**DOCUMENT 00 90 00  
ADDENDUM**

**ADDENDUM NO. [2]                      Date: January 5, 2022**

**RE:                      SCHOOL DISTRICT OF ABBOTSFORD  
ABBOTSFORD SCHOOL DISTRICT FEMA ADDITION  
510 WEST HEMLOCK STREET  
ABBOTSFORD, WISCONSIN 54405  
HSR PROJECT NO. 21027**

Project Title: **ABBOTSFORD SCHOOL DISTRICT  
FEMA ADDITION**  
Project Location: **510 WEST HEMLOCK STREET  
ABBOTSFORD, WISCONSIN**  
Sheet Title: **EXTERIOR ELEVATIONS**

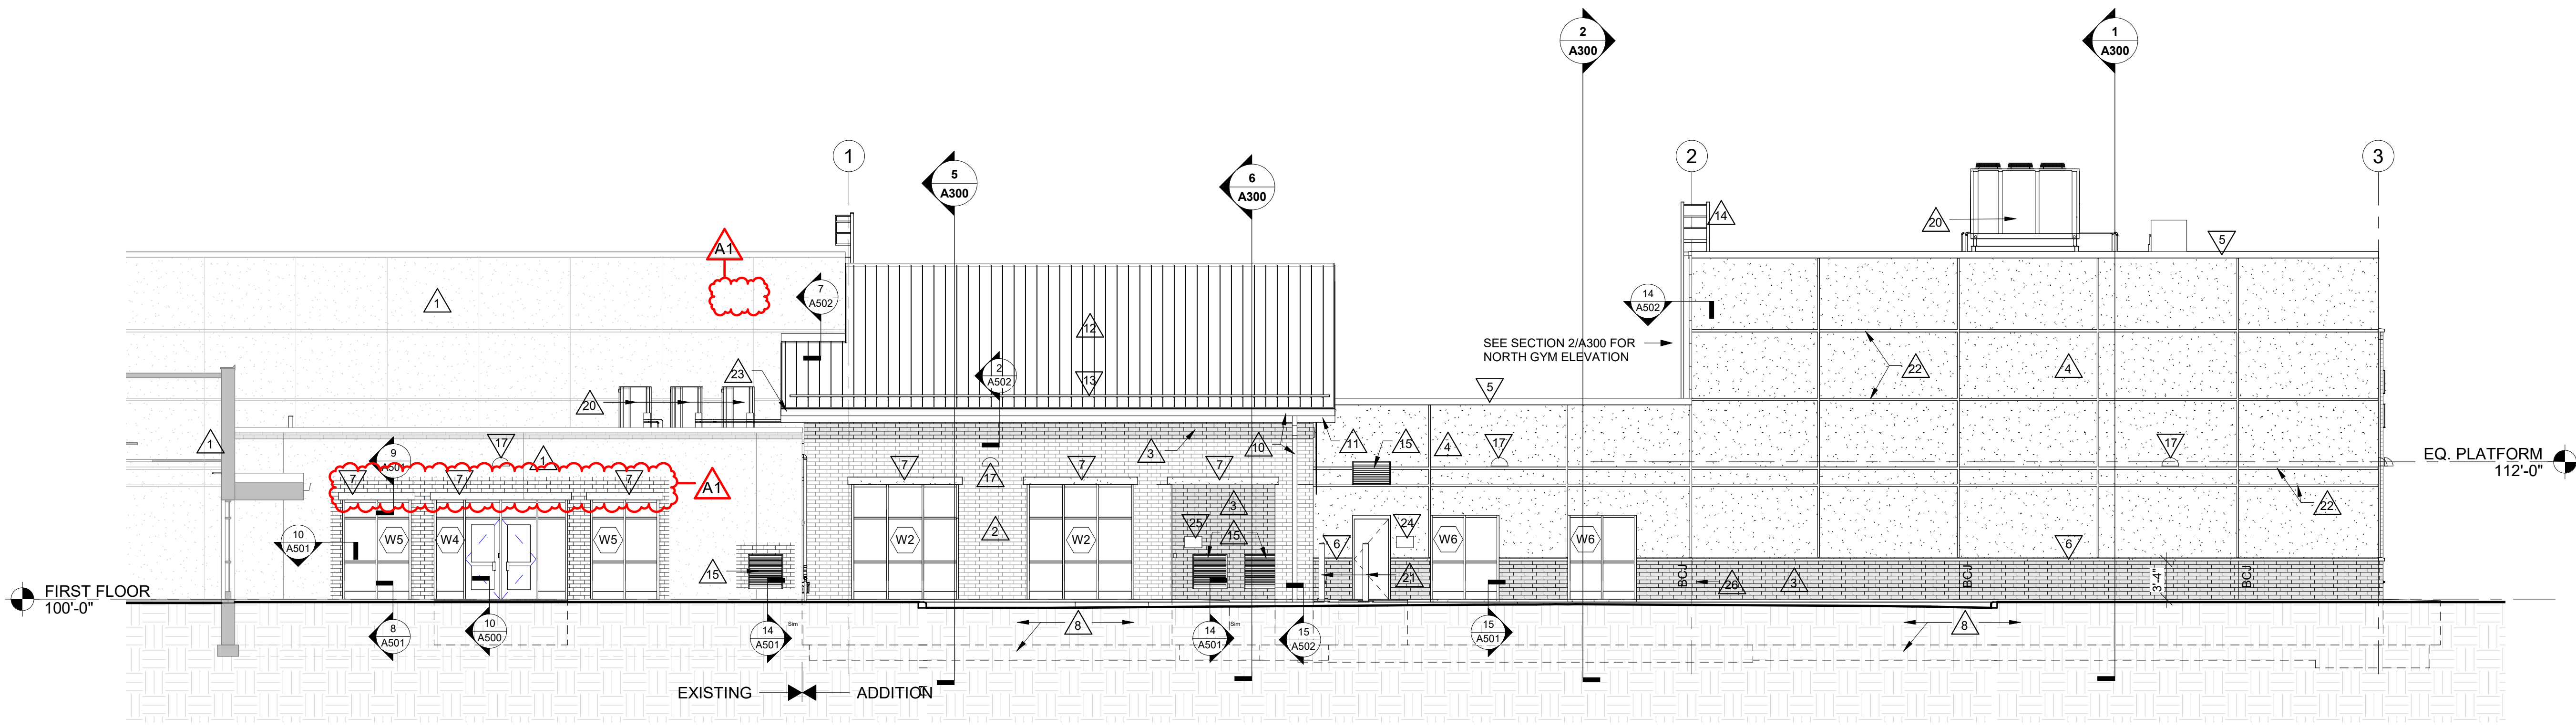
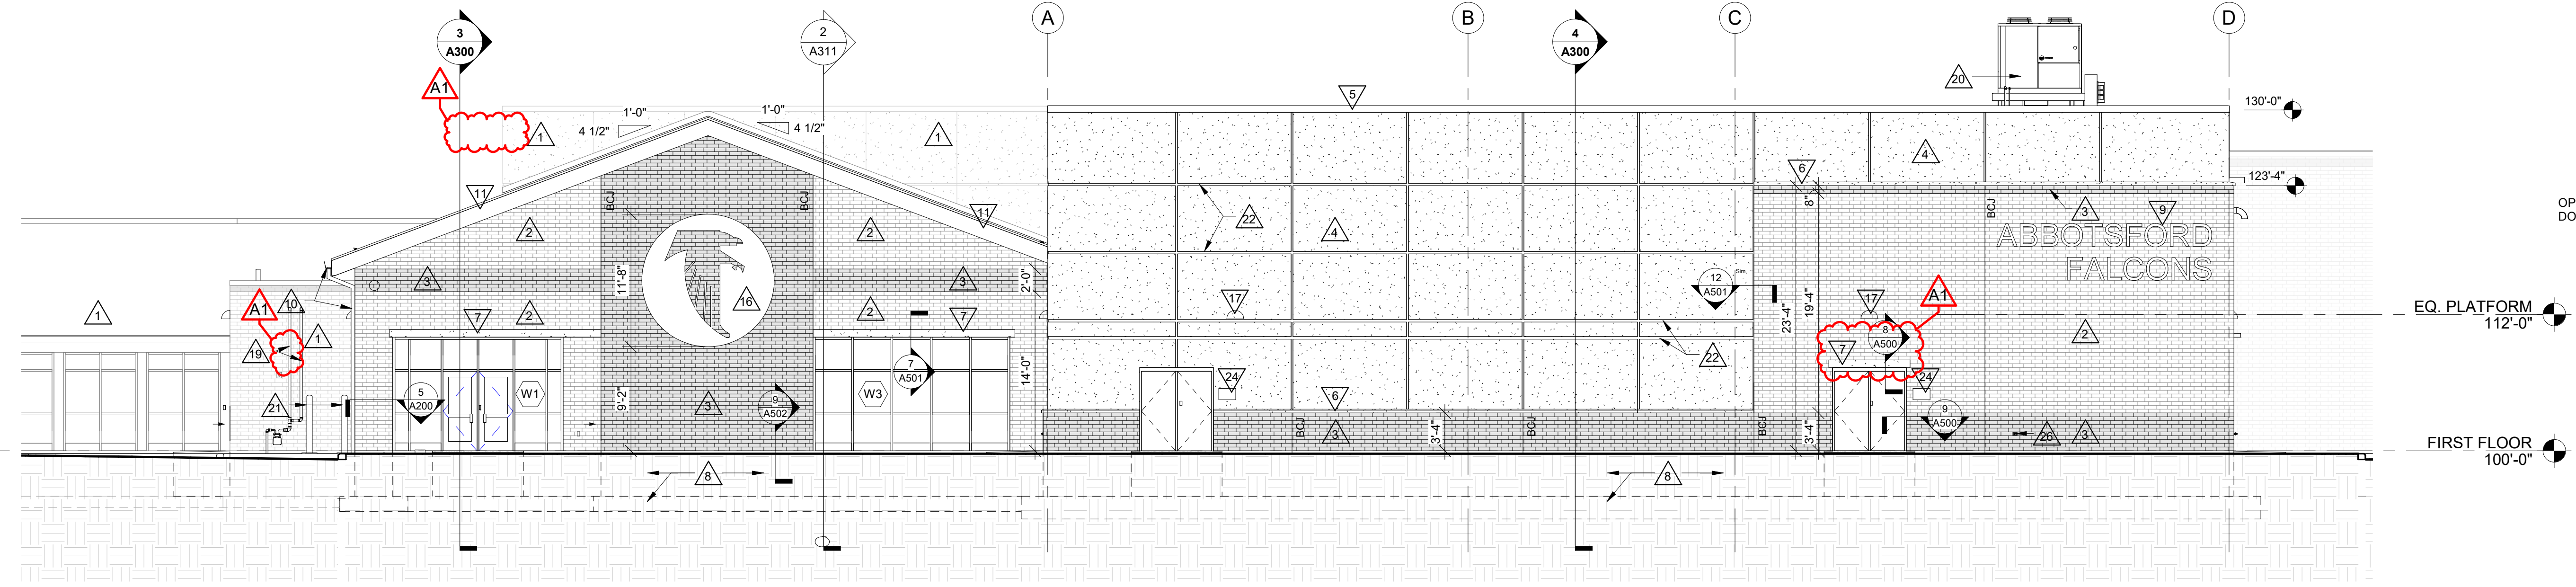
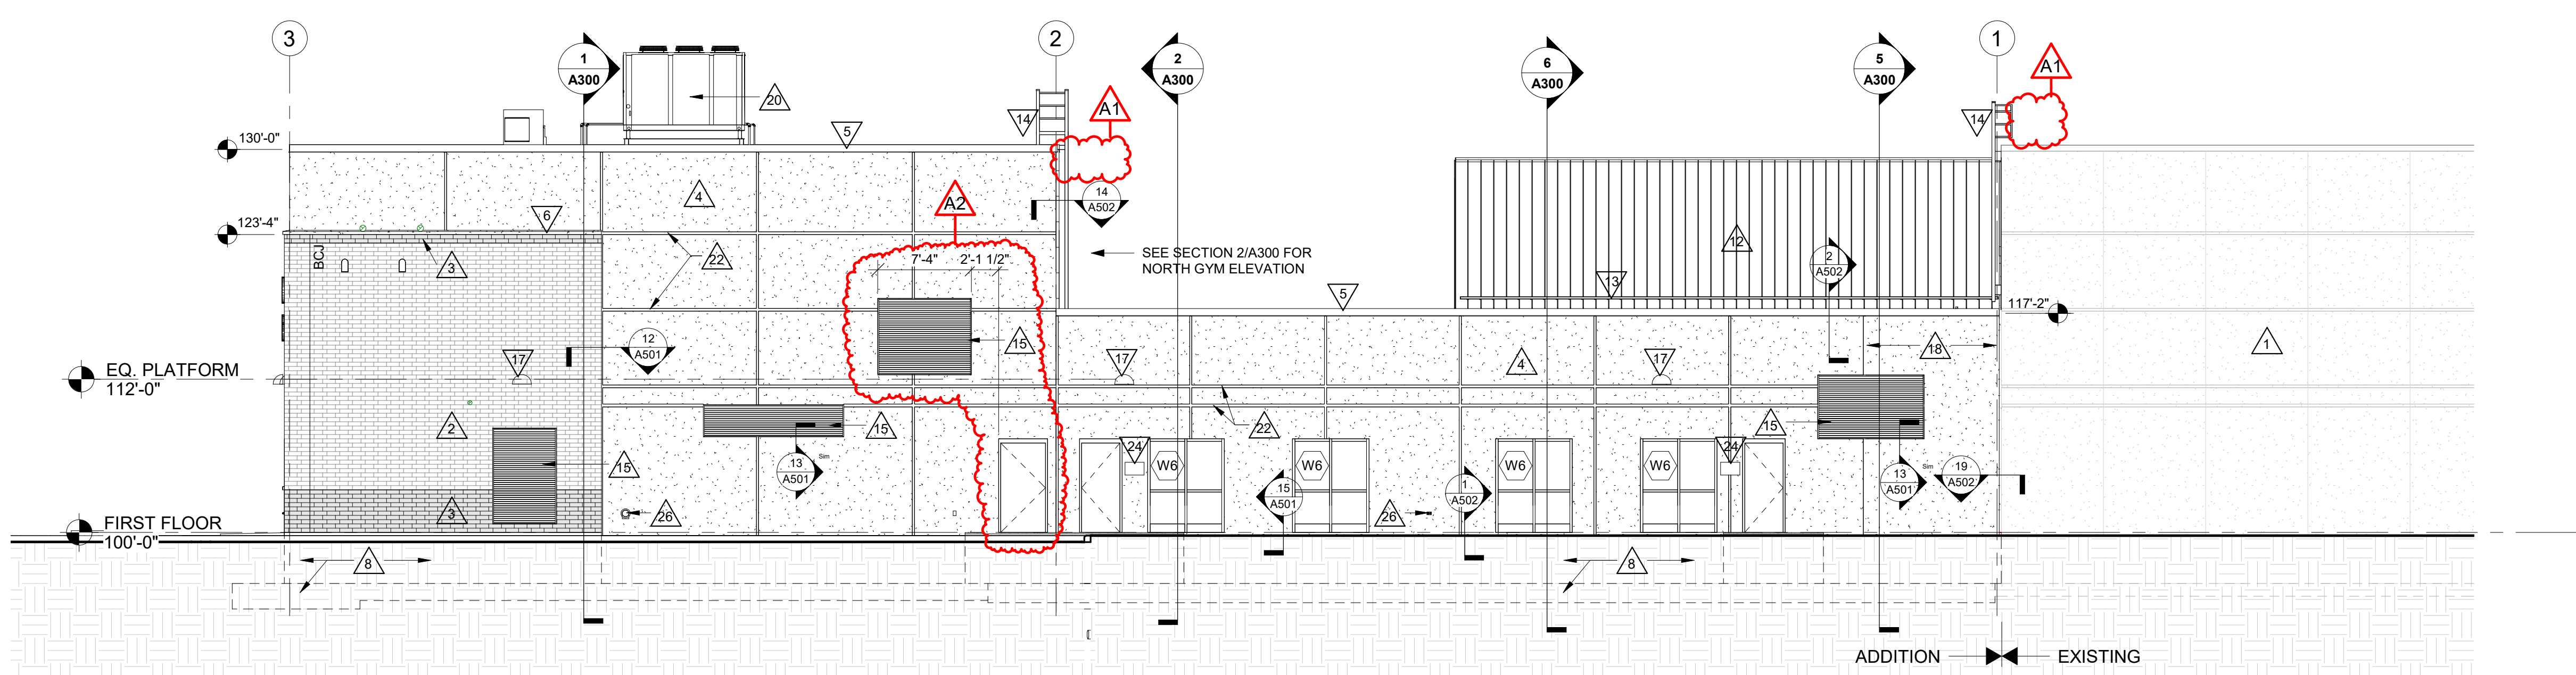
15. Sheet A200 EXTERIOR ELEVATIONS revised 30 x 42 sheet attached hereto.

- a. Change dimension of louver and relocated door.
